Entergy Nuclear Operations, Inc.  
Palisades Nuclear Plant  
27780 Blue Star Memorial Highway  
Covert, MI 49043

Palisades Nuclear Plant  
Docket 50-255  
License No. DPR-20

Response to Request for Additional Information Regarding License Amendment  
Request for Emergency Core Cooling Systems Surveillance Requirement  
(TAC No. MD5259)

**ENCLOSURE 1**  
**RAI RESPONSE ON ECCS SURVEILLANCE REQUIREMENT LAR**  
**PALISADES NUCLEAR PLANT**

**ATTACHMENT 2  
DRAIN PLUG CONFIGURATION**

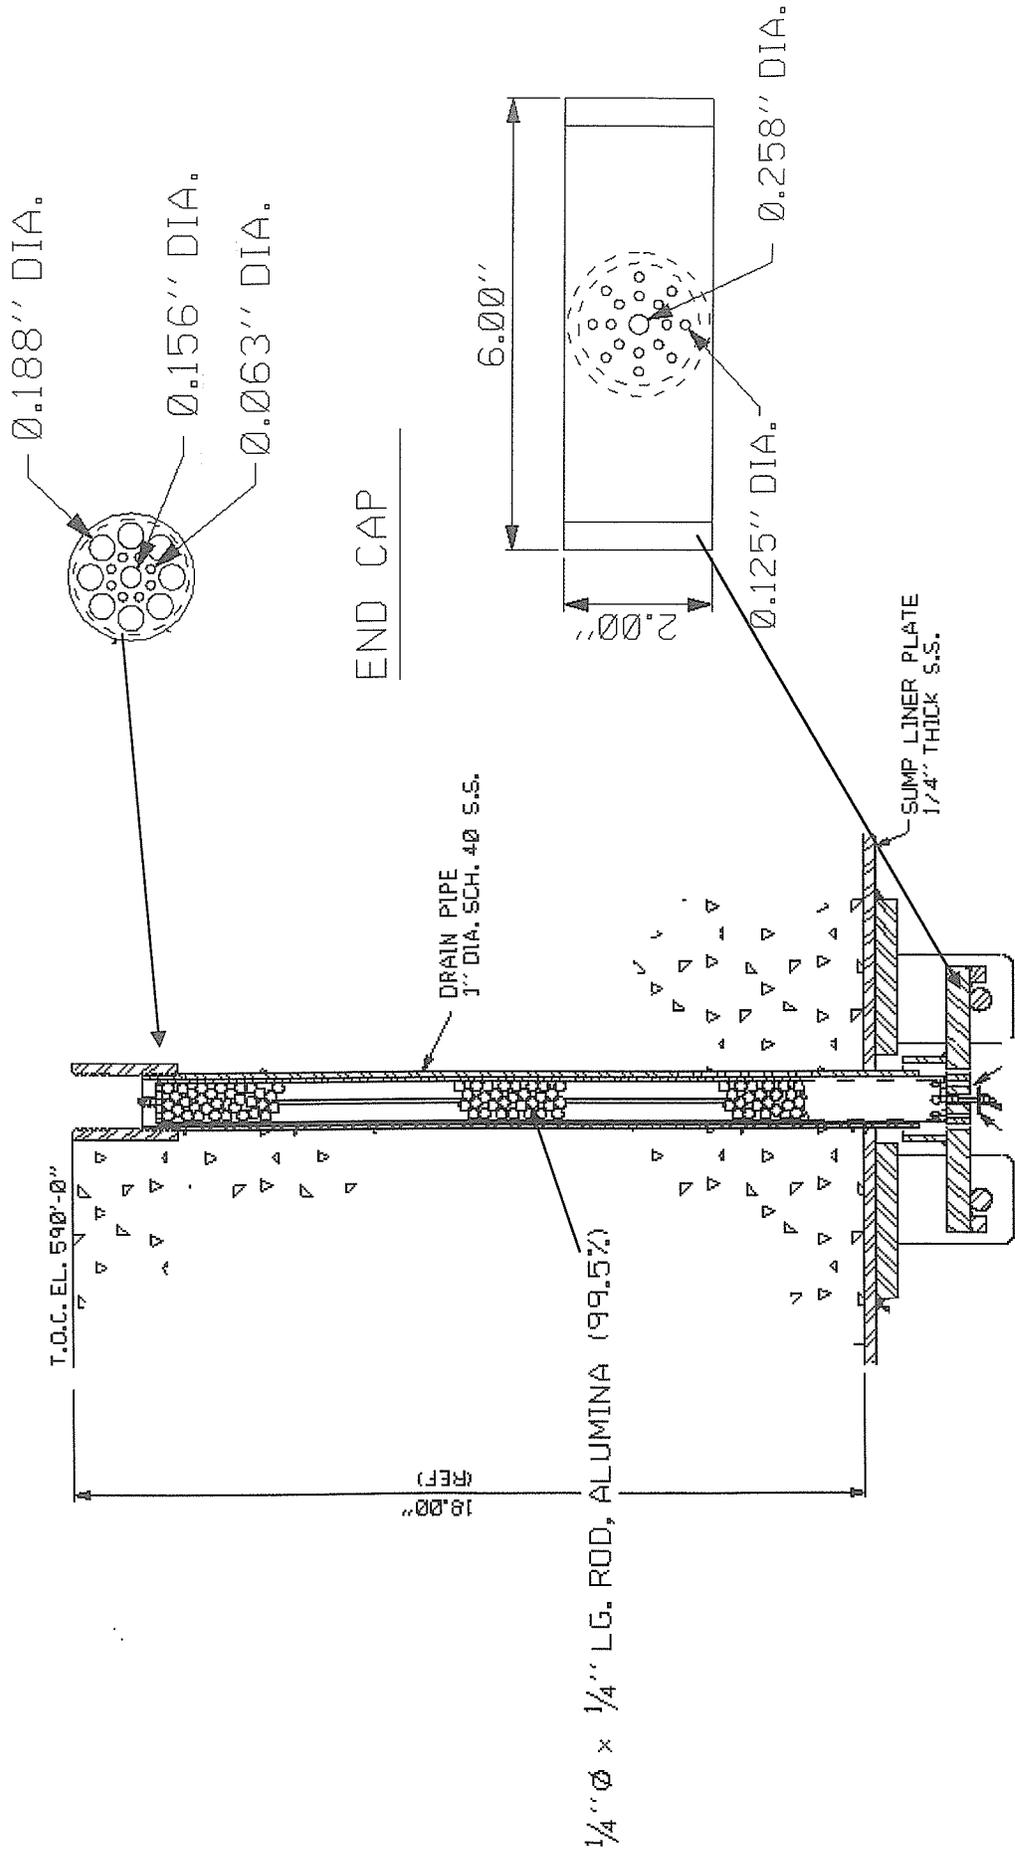
During the June 14, 2007, teleconference the NRC staff requested a more detailed description of the corium plugs and their function. This information is provided below.

The two one-inch drain lines at the bottom of the reactor cavity contain drain plugs designed to inhibit the flow of core debris (corium) into the containment sump in the event of a core meltdown and subsequent reactor vessel failure. The plugs are also designed to permit the normal flow of water through the drain lines. The corium plugs form an inherent debris screen equal to the 0.045" perforated debris screens protecting the containment sump envelope.

The corium plugs were installed in 1996 as part of a plant modification. The modification consisted of inserting stainless steel canisters containing ceramic pellets into the two one-inch reactor cavity drain lines to restrict the flow of corium into the sump in the event of a reactor vessel breach. The pellets have a melting temperature on the order of 3400 °F and are stable under normal operating and design basis accident environmental conditions. The canisters are designed to withstand an instantaneous blast load from the reactor vessel coincident with a seismic event. The canisters are designed to permit normal water drainage. The drain lines do not have any active components. The reactor cavity flooding system is not included in the mitigation of any design basis event. A core melt/reactor vessel bottom failure is not a design basis event.

The details for the drain line plugs are shown on plant Drawing M74, sheet 1. A portion of this drawing showing the drain line configuration (Detail B) is provided as Attachment 1. The drain plug detail is shown on plant Drawing M74, sheet 2. A portion of this drawing showing the cavity drain plug configuration is provided as Attachment 2.

Under a design basis LOCA, the reactor cavity flooding system debris laden water collected in the floor drains above the 590' elevation transports into the reactor cavity. The post-LOCA fibrous debris transported in the reactor cavity bridges and deposits on the 0.188" and 0.063" cavity drain plug end cap openings and/or in the tortuous pathway created by the ¼" diameter, ¼" long ceramic pellets contained in the 18" long cavity drain plug, and effectively plugs and prevents debris flow through the two cavity drain lines into the containment sump.
